Work Order ID 113971

Item ID: D212-664-201TRN Accept *N9000040100* Setup Start *NS1*
 Revision ID: Stop *NS2*
 Item Name: Crosstube Turning Detail
 Start Date: 2/28/14 Start Qty: 1.00 *1* Cust Item ID:
 Required Date: 3/14/14 Req'd Qty: 1.00 *1* Customer:
 Reference:

DART AEROSPACE LTD		Work Order:	113971
Description: Crosstube Assembly (205/212 High Aft)		Part Number:	D212-664-241
Inspection Dwg: D212-664-241 Rev: D		Page 1 of 2

DRAWING NO. D212-664-241	TITLE CROSSTUBE ASSY (205/212 HI AFT)	REV. D	DART AEROSPACE LTD ENGINEERING ORDER		D.E.O. NO. D212-664-241-D-1	SHEET NO. SHEET 1 OF 2	SCALE NTS
DRAWN	CHECKED	MFG. APPR.	APPROVED	DE APPR.			
DATE 11.04.07	DATE 11.04.11	DATE 11.04.12	DATE 11/04/12	DATE 11.04.12

**D212-664-241/-241B
ASSEMBLY DETAIL**

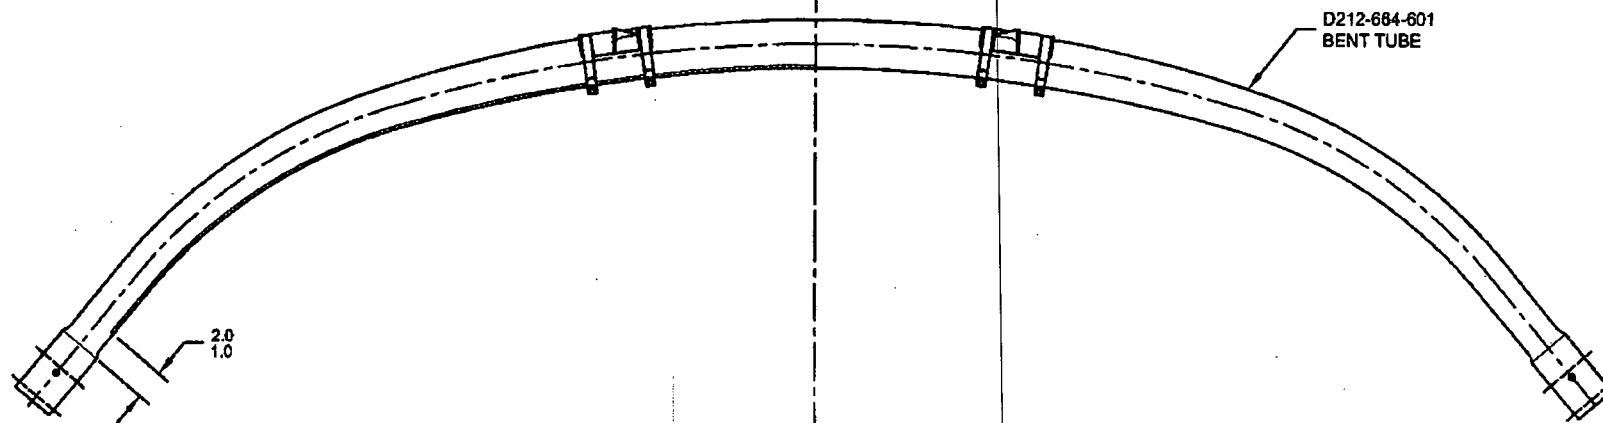
PURPOSE:

ADD AN INSPECTION WINDOW TO UNDERSIDE OF CROSSTUBE.

IS:

WAS:

MASK AREA PRIOR TO PAINTING,
REMOVE MASKING AFTER PAINT
AND APPLY CLEAR COAT
